Planning, Zoning, and Building Department

BOARD ACTION REPORT – APPEALABLE ITEM

Project Name: Chili's at Delray Square (2017 -208)
Project Location: 14530 South Military trail
Request: Class IV Site Plan Modification
Board: Site Plan Review and Appearance Board
Meeting Date: October 11, 2017

SHEET NUMBER
C1.00

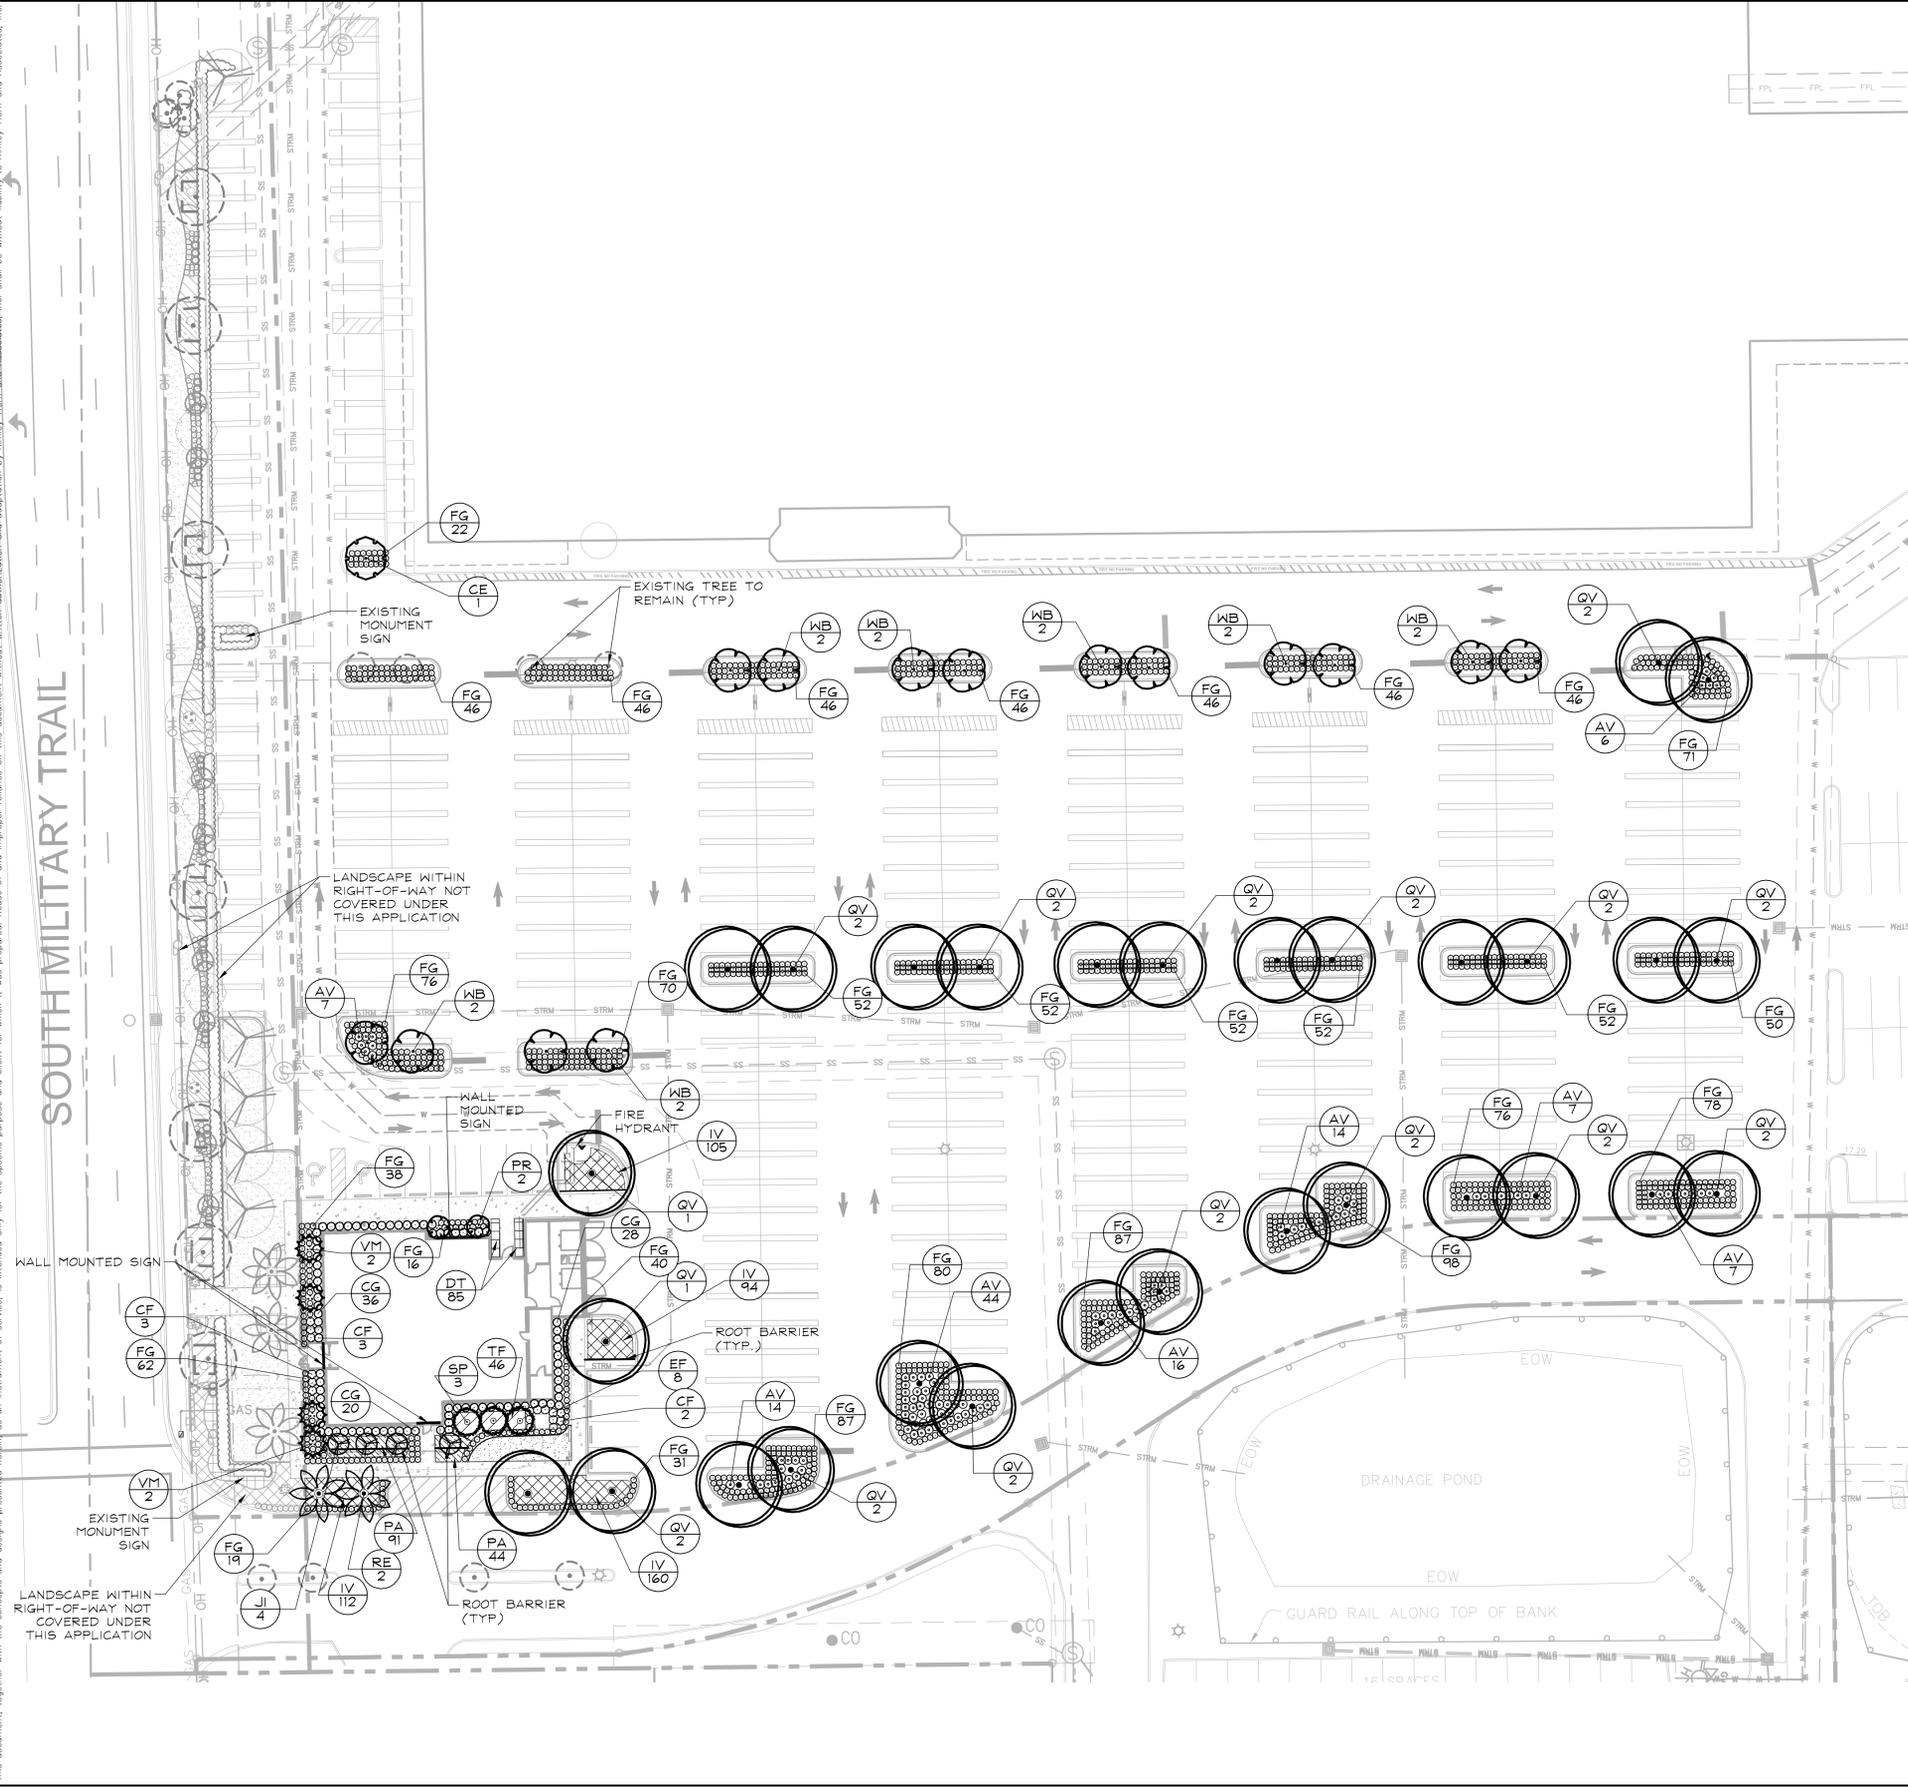
SITE PLAN ANALYSIS

The proposed lighting consists of under canopy fixtures, wall fixtures, and freestanding poles adjacent to the building. The proposed values are within the permitted minimum and maximum ranges, which comply with the requirements of LDR Section 4.6.8(B)(3), Illumination Standards.

Pursuant to LDR Section 4.6.16(H)(3)(n), all dumpster and refuse areas shall be screened. The proposed refuse area is located interior to the property, facing away from the public right of way, but

adjacent to the main drive aisle and parking area. The area will be screened by a split face concrete wall and accessed by wood gates.

SHEET TITLE:
EXTERIOR ELEVATIONS

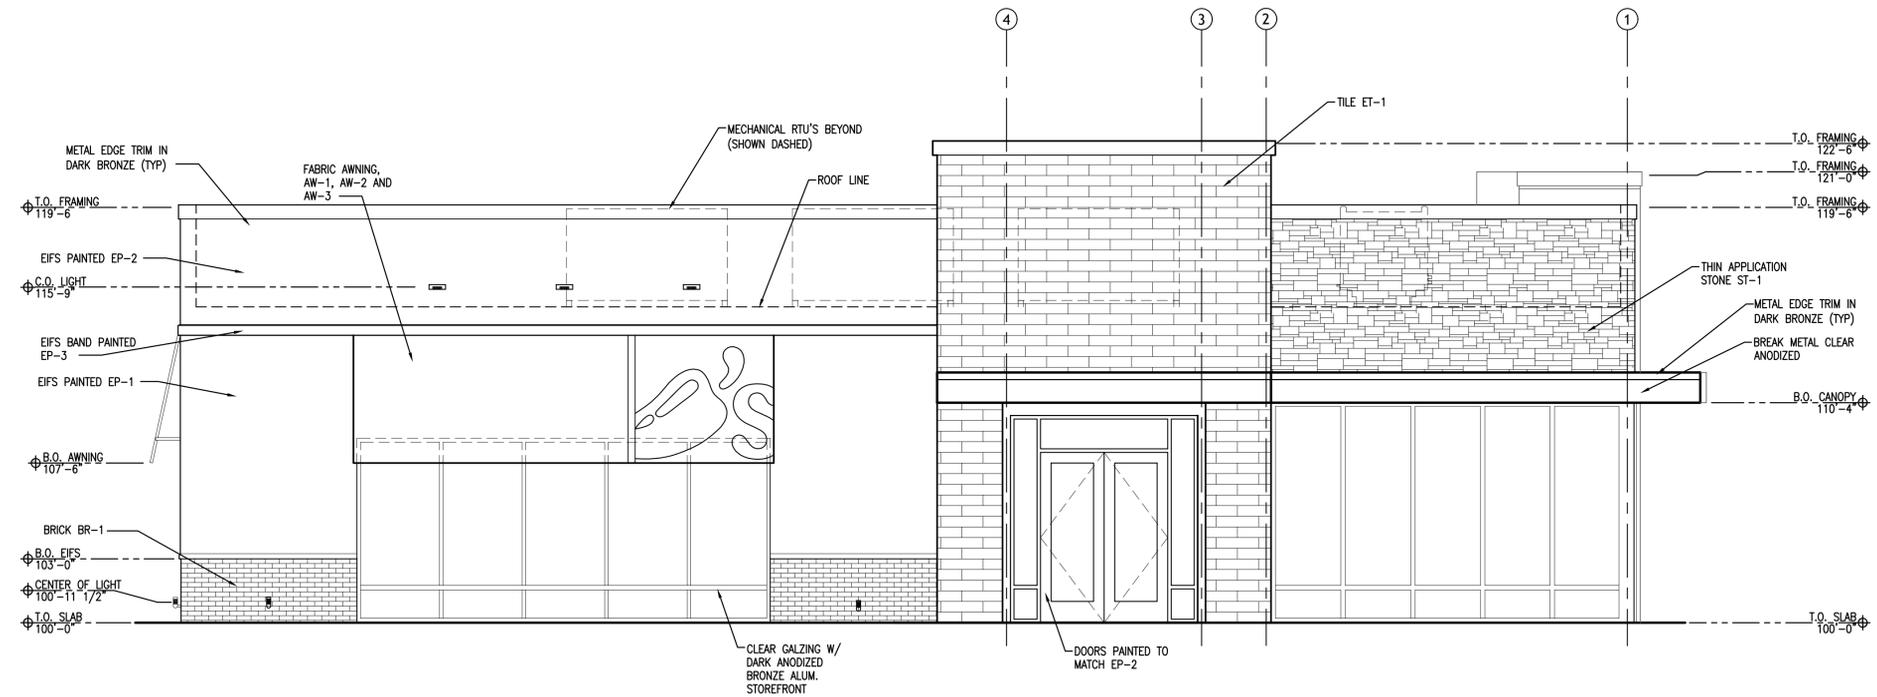
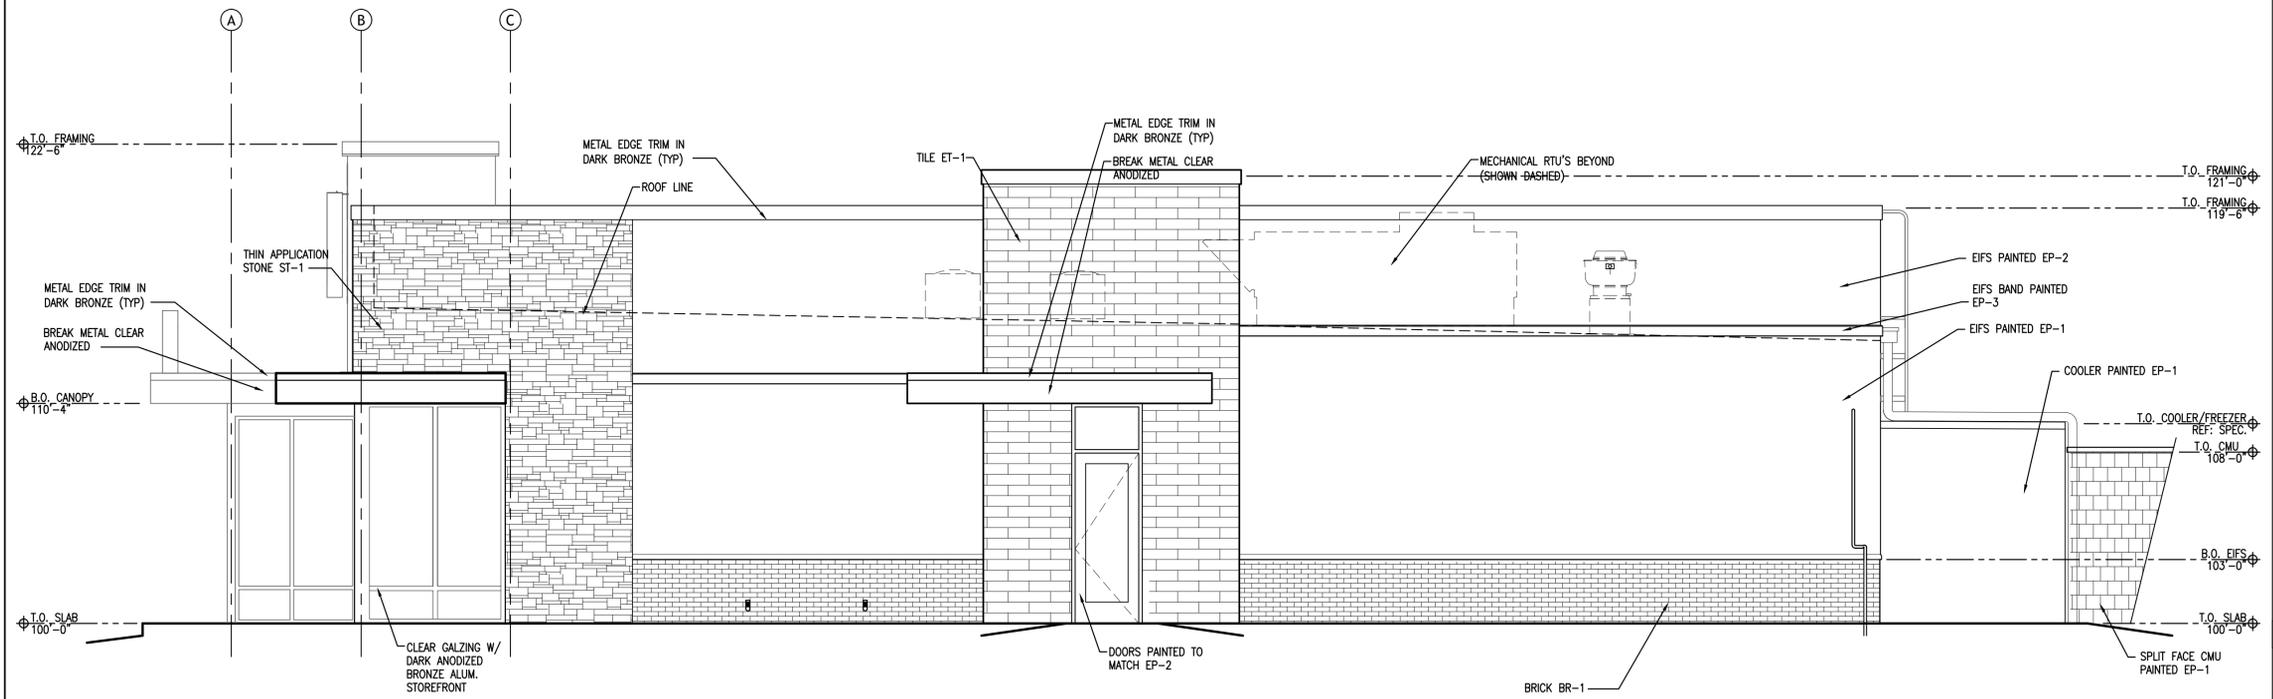
The proposed facade elevations are typical of the well-known and easily identifiable chain restaurant which are not contrary to the intent of the applicable criteria above. The exterior finishes consist of a stone, tile, and brick veneer which accent the painted stucco. The color scheme is generally earthy with red and green accents.

The elevations are generally in good taste and will not materially depreciate the surrounding environment. Additionally, they are not inconsistent with the shopping center, and will be harmonious with both the existing development and proposed improvements for the site. Therefore, positive findings can be made with regard to the criteria listed in LDR Section 4.6.18(E). In addition to the criteria noted above, the Four Corners Overlay District requires that any free-standing non-residential structure be architecturally consistent with other structures in the master development plan. The architectural consistency is evidenced in the low-scale building which demonstrates typical suburban design.

Approve the Architectural Elevations (2017-208) for Chili's at Delray Square located at 14530 South Military Trail, by adopting the findings of fact and law contained in the staff report, and finding that the request and approval thereof is consistent with the Comprehensive Plan and meets criteria set forth in LDR Section 4.6.18(E).
